Access Compliance Report

Public Rights-of-Way

(Curb Ramps)

Intersection ID: 29684	Main Street: CAMERON_CREEK_DR	Cross Street: HAMPTON_GLEN_CT	Location: W
ADA ID: 6B432183F6A5	Ramp Type: PerpDiag	Initial Pass/Fail: Fail	Overall Compliance: No
Severity Score: 8.75			
Codes/Mitigation Info/Possible Solution		Field Measurements/Component Compliance

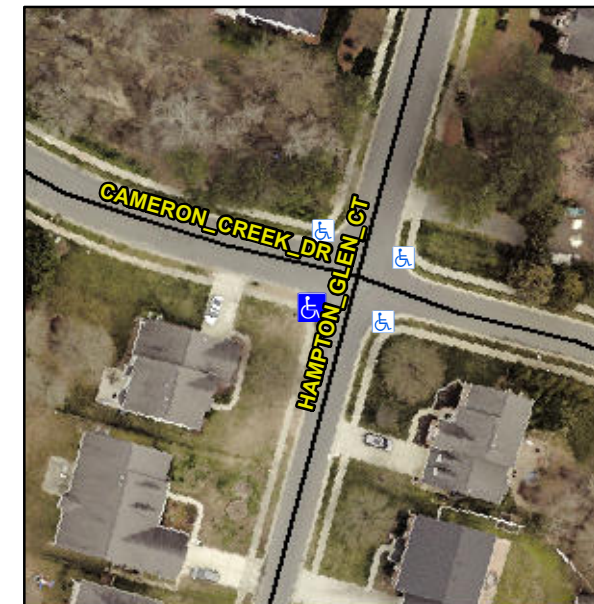
Not Found, R304.5.1

Compliance	Description	Data	Compliance	Description	Data
N/A	Ramp Length (in)	49.5	Yes	Ramp Slope (%)	6.2
No	Ramp Width (in)	44.0	Yes	Ramp XSlope (%)	0.2
N/A	Flare Type LT	N/A	N/A	Flare Type RT	N/A
N/A	Flare Slope LT (%)	N/A	N/A	Flare Slope RT (%)	N/A
N/A	Flare Traversable LT?	N/A	N/A	Flare Traversable RT?	N/A
N/A	Landing Length (in)	N/A	N/A	DWS Provided?	N/A
N/A	Landing Width (in)	N/A	N/A	DWS Contrast?	N/A
N/A	Landing Slope (%)	N/A	N/A	DWS Length (in)	N/A
N/A	Landing X Slope (%)	N/A	N/A	DWS Full Width?	N/A
N/A	Landing Curb? (Y/N)	N/A	N/A	DWS Offset (in)	N/A
N/A	Shared Landing?	N/A			
N/A	Gutter Ponding?	N/A	N/A	Gutter Slope (%)	N/A
N/A	Gutter Lip Ht (in)	N/A	N/A	Gutter X Slope (%)	N/A
N/A	Painted X Walk1?	No	N/A	Painted X Walk2?	No
	X Walk 1 Direction	To NE		X Walk 2 Direction	To SE
N/A	X Walk 1 Width (in)	N/A	N/A	X Walk 2 Width (in)	N/A
	X Walk 1 Slope (%)	2.2		X Walk 2 Slope (%)	0.7
	X Walk 1 X Slope (%)	1.2		X Walk 2 X Slope (%)	2.0

Remove & Replace Curb Ramp With Two New Directional Ramps or Equivalent.
